SUTHERLAND SHIRE COUNCIL ASSESSMENT REPORT

Panel Reference	PPSSSH-141
DA Number	DA23/0380
LGA	Sutherland Shire
Proposed Development:	Demolition of existing structures and construction of a residential flat building with the provision of affordable housing as provided for under the State Environmental Planning Policy (SEPP Housing) 2021
Street Address:	26 Rosebery Street, Heathcote (Lot 16 Sec A DP 2499)
Applicant/Owner:	Pacific Community Housing Pty Limited
Date of DA lodgement	20 June 2023
Number of Submissions:	First period of public notification: 124 Second period of public notification: 30
Recommendation:	Approval
Regional Development Criteria	Clause 5, Schedule 6 State Environmental Planning Policy (Planning Systems) 2021 - CIV > \$5M – Private infrastructure and community facilities (affordable housing)
List of all relevant s4.15(1)(a) matters	<ul style="list-style-type: none"> • State environmental Planning Policy (Housing) 2021 • State Environmental Planning Policy (Planning Systems) 2021 • State Environmental Planning Policy (Resilience & Hazards) 2021 • State Environmental Planning Policy (Biodiversity & Conservation) 2021 • State Environmental Planning Policy (Transport

Figure 7: Applicant's Height of Building 'FOG' diagram

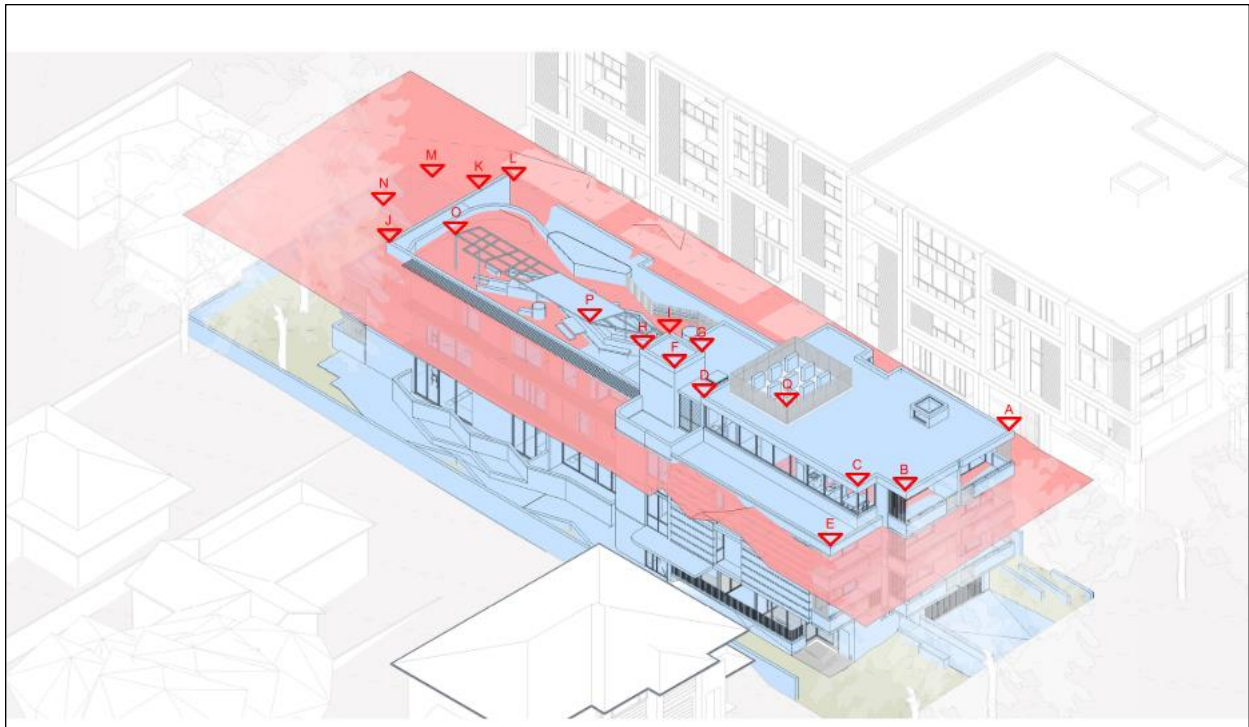
The final elevations illustrate some key building heights and Page 9-10 of the Building Height Clause 4.6 Variation Request includes a Height Blanket diagram and corresponding table (reproduced at Part 11.1 below). It is noted that there remain some minor anomalies within the elevation plans. By way of example a measurement of 9.3m (at point "E" to height schedule table) is provided to the northern elevation 3 storey parapet (which appears from BB Section to be RL 197.46 not RL 196.75), however as calculated by Council's Architect and Assessment Officer this more accurately reflects 10m as it sits above ground line RL 187.45. In addition, the 4 storey parapet height (at point "B") indicates top RL of 187.97, notably a typo which was anticipated to be corrected, however remains on the final plans. Finally the pergola RL indicates 199.55 in the height schedule table, whereas RL199.95 on the elevation plans.

In light of some measurement anomalies (which are considered necessary to point out as the issue of inconsistencies in detail are reasonably raised in neighbour submissions), the building height at point “E” does not provide an unnecessarily high parapet and nothing turns on this regarding excess bulk or shadow impacts with the level above being setback 6m. Furthermore, an assessment has been undertaken regarding building height variation and suitability of building scale pursuant to Clause 4.6 of SSLEP 2015 below at Part 11.1 of this report.

From a statutory position the critical maximum building height (at points F, G, H, I and Q) being the lift overrun and plant screening are confirmed with calculations by Councils Assessment Officer and Architect consistent with the applicants.

The applicant is seeking to vary the building height development standard resulting from the requisite measurement being taken from the existing ground level (by SSLEP 2015 height definition) to a maximum height of 13.7m to the lift overrun and plant screening (see “F” and “Q” in table 2 below). This results in a variation of 52.2%. Furthermore, key areas of height include:

- Lift overrun – 13.70m (52%) – Maximum breach
- 4 storey component – 12.85m (39.5%)
- Roof top plant screening – 13.7m (52%) – Maximum breach
- 3 storey component – 9.95m (10.5%)

Figure 8: Southern elevation of existing dual occupancy adjoining site to the north

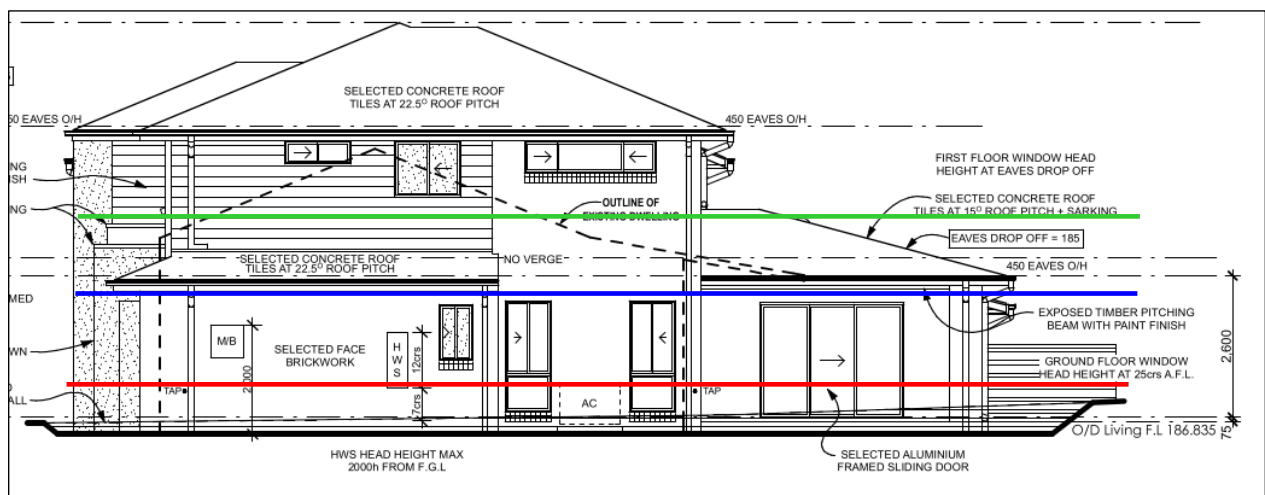
A large number of submissions have raised the issue of reduced privacy. Whilst it is recognized that the subject development will accommodate dwelling stock above that anticipated within the R3 – Medium Density Zone, the site has been identified through the certification by DPHI to be capable of accommodating the scale and number of dwellings proposed within a RFB. On balance, and contemplating the design guidance, development proposal and site context, the proposal is considered to provide acceptable privacy for adjoining properties. This is achieved through the provision of solid walls at 3m setbacks and introducing openings to habitable units above ground level with 6m or more setback from shared boundaries.

Adjoining the site to the north is a 2-storey dual occupancy at No. 24 Rosebery Street. This building locates several windows to habitable and non-habitable uses facing the subject site. The ground and first floors of the proposed development will sit approximately 1m above No. 24, such that the FFL of unit A104 will sit close to the sill height of the bathroom (red line below). Boundary fencing available at 1.8m height would screen up to the ceiling height (blue line below).

Likewise, the proposed Level 2 will sit approximately 1m above the First Floor FFL of No. 24 (green line in Figure 8 above) and whilst the proposed building is setback 3m from the boundary, only blank walls (with the exception of the lobby window, discussed below) face north.

Figure 10: Excerpt from Landscape Plan showing location of T6-9 along northern boundary

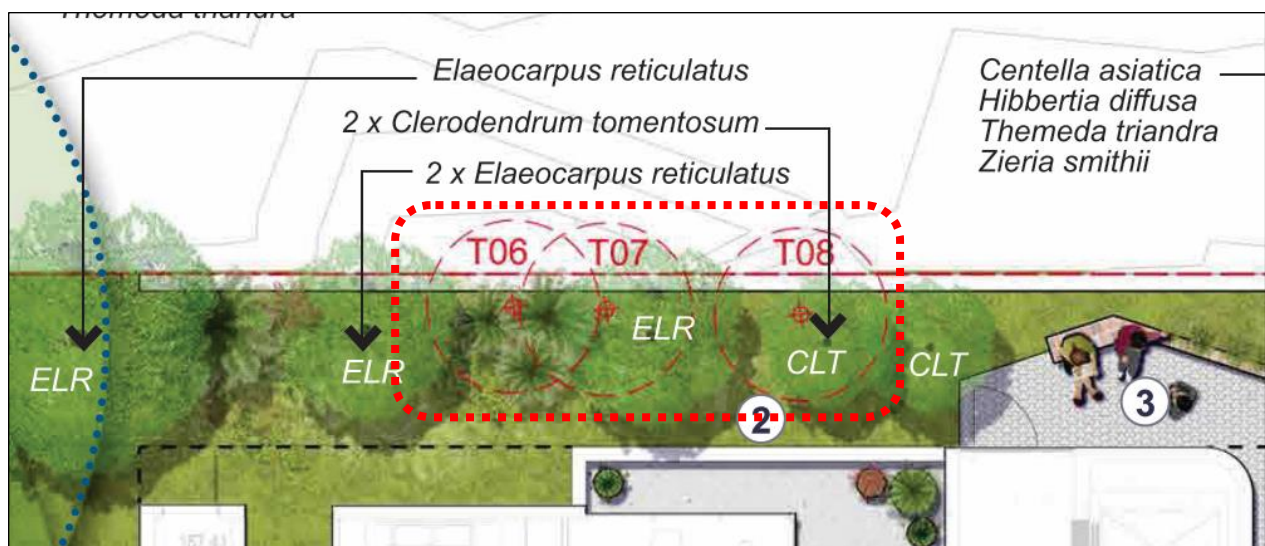
There are 3x existing Yunnan Poplar trees at the site along the northern boundary (T6, T7 and T8) which are identified for removal. Whilst not native, retention would provide benefit to No. 24 by improving outlook and providing visual relief. The submission includes a request by occupants of No. 24 that these trees be retained. Furthermore, the DRP specifically notes that these trees can be retained as they are clear of the building works and excavation of the carpark. Retention of these trees has been included in the draft consent conditions.

Figure 12: Relationship between rear of development and No. 14 Strickland Street

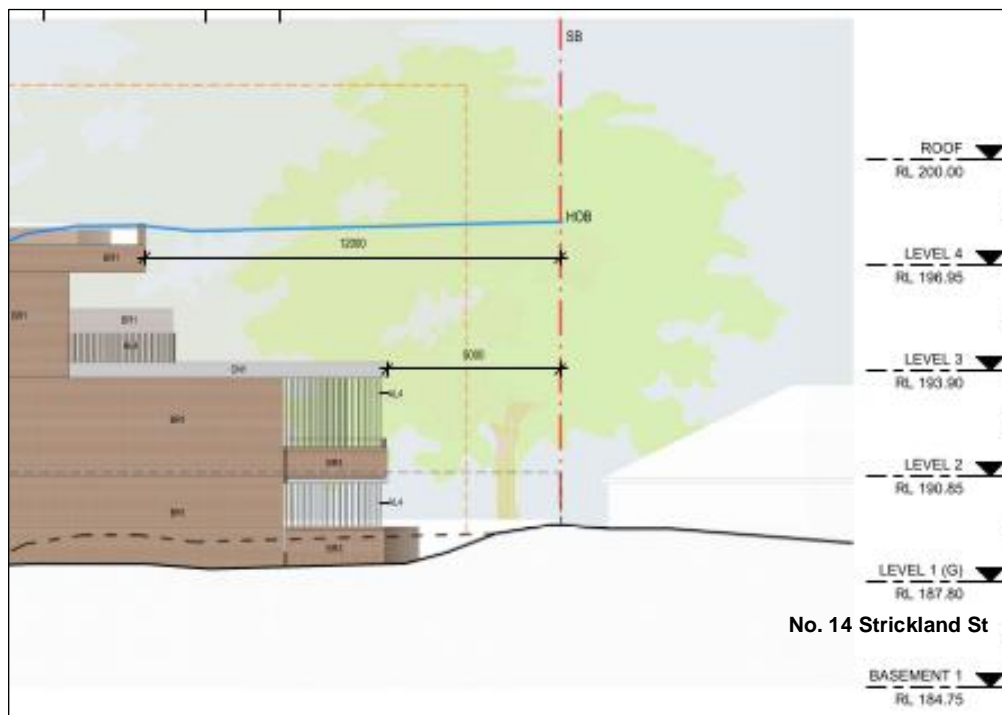
The proposed building steps from 4 storeys at the front to 3 storeys beyond the lift overrun and 2 storeys at 5m from the rear (eastern) boundary. To the rear is a single storey villa forming part of a multi-dwelling complex accessed from Strickland Street. The villa is setback approximately 1.5m from the shared boundary with an eave height at RL 191.52 which is approximate to proposed Level 2 FFL (at RL 190.8). This results in Level 2 sitting 700mm below the eave and remaining Level 3 and roof terrace sitting above and viewing over the roof line. The Level 2 balcony (A201) is setback 5m from the eastern (rear) boundary. Within the setback is retention of high quality mature trees to the north-eastern corner and new planting of a Turpentine tree capable of generous height.

The setbacks are 4m (Ground/L1), 5m (L2), 11.2m (L3), and 12m (L4) which satisfy the DCP setback (and storeys) requirements.

Figure 13: Aerial view showing southern adjoining site and distance from bushland outlook

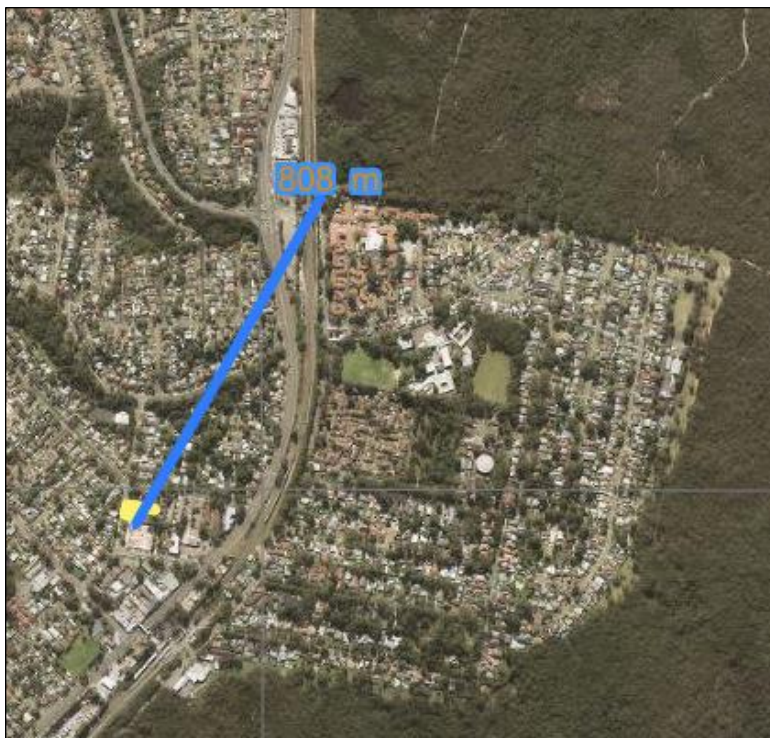
Neighbour submissions have raised a concern of view loss from upper-level units in the adjoining RFB to the south. The view loss is stated as being of a north, north-easterly view to the Royal National Park. These views are better described as “outlook” rather than a primary view and are very distant measuring over 800m from the site and adjoining land as demonstrated below in **Figure 13**.

Figure 14: South elevation of proposed development showing HOB and storeys at rear (viewed from adjoining RFB)

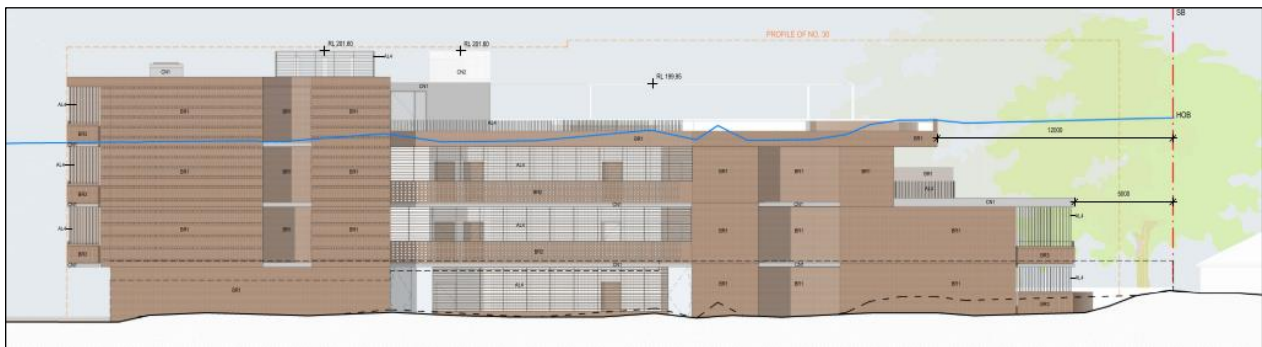
It is acknowledged, that outlook across the site will be reduced from development. **Figure 14** below shows the elevational treatment along the shared boundary with the adjoining RFB to the south. It is noted that outside the SCC process, a 3 storey townhouse would be permitted at this site up to 9m with the same rear setback, such that reduction in outlook would occur for the adjoining units at Ground, Level 1 and Level 2. It is necessary to balance all planning aspects of this proposal and whilst there will be a reduction in outlook (and more compared to a compliant scheme), they are not primary views and the height at the rear is close to the maximum limitation of 9m (for 62% of the building length). The rooftop COS does sit in this level however, is well set in from southern boundary, includes a light pergola structure on the northern side and low bench / planter treatment at 600mm height.
